UBCO Service Bulletin

ID	UBC00013
DATE	18-February-2020
MODEL	2018 2x2
PRODUCTION	Vin Numbers Between L5XU1AAB9J600001 to L5XU1AAB9J600581
MARKETS	New Zealand, United States and Australia
TYPE	Service Notification
TITLE	Speedometer Mounting & Clock Setting
ISSUE	A number of failures of the speedometer housing & wiring connection have been reported on bikes with VIN numbers between J600001 to J600581. The failure mode has been identified as being excessive vibration from the handle bars passing through to the mounting bolts of the speedometer. This can cause the display not to function correctly. It also has been noted that in certain cases that when the bike is turned off or power removed from the clock, the time on the clock resets back to zero. This is the result of a missing capacitor on the PCB.
REMEDIATION	A kit will need to be ordered and fitted to the bike, part number, KIT-HLDSP-0-001. The kit includes: • New Speedometer – With corrected clock function on PCB. • New Bracket Assembly. • Edge protection • Assembly Instructions and guidance. This kit is available for ALL bikes in the VIN code range. The new speedometer will show 0 km or miles. The existing kms or miles ridden

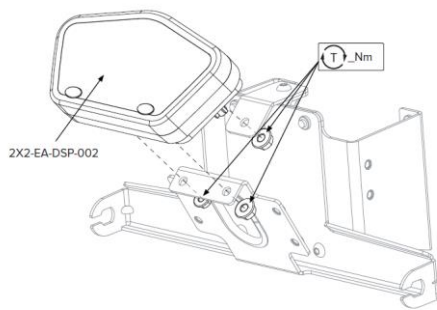
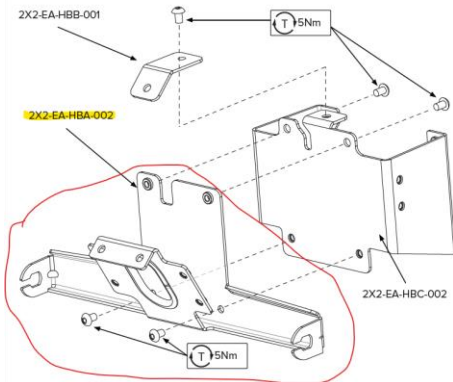
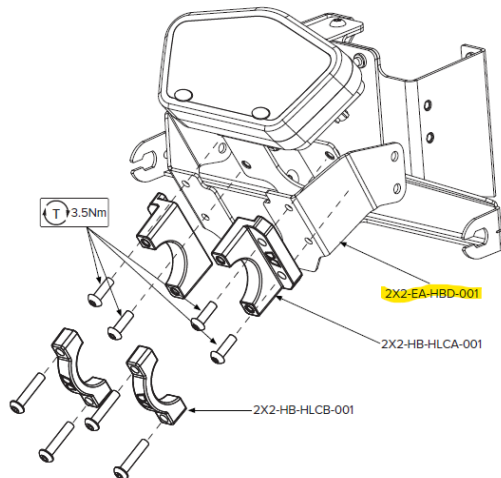
Turn the bike on and record the odometer reading. This is required for the warranty claim. The new speedometer will be set at zero distance. However the bike run time will still be retained within the ECU and can be viewed through the app. Once recorded turn the bike off	
Remove the outside bracket (2x2-EA-HC-002) that surrounds the headlight.	
Disconnect the indicator wiring and remove the indicators from the mounting bracket	
Remove the headlight and disconnect the associated wiring.

Remove the front control panel cover by removing the 8 T25 Torx screws down each side	
Disconnect the speedometer from the ECU at the plug between the two components. The wire will run through the left hand side of the console assembly. The lead will be labelled "Display to ECU"	
Remove the speedometer assembly by undoing the allen key bolts on the handlebar clamps that hold the assembly to the handlebar.

Disconnect the speedometer from the mounting bracket	
Replace the 2x2-EA-HBA-002 indicator bracket that holds the indicators with the one supplied from the kit. Ensure the edge protector from the original headlight bracket is re used on the new one.	
Refit the new speedometer supplied to the assembly. Then fit the supplied new headlight bracket 2x2-HB-HLCA-001 to the rear of the assembly as shown below securing the handle bar brackets with the cap screws.	
The new headlight bracket 2x2 HB-HCLA-001 will attach to the outside of the 2x2-EA-HC-002 headlight bracket.

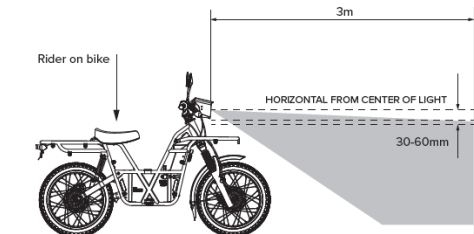
Re-connect the new speedometer to the ECU Ensure the cable assembly passes through the clearance hole. Refit the front cover assembly	
Re-attach the assembly so it is snug to the handlebars. Reconnect all wiring to the headlight and indicators. Reassemble the indicators to the mounting bracket.	
The assembly will need to be rotated to ensure the correct position of the headlight. Once correctly located tighten up the handlebar brackets.	
Reattach the headlight cover to the headlight assembly as shown	
Turn the bike on and test headlight and indicator operation to ensure correct operation. Verify new display operates and set time and distance units. New display will show 0 distance travelled.
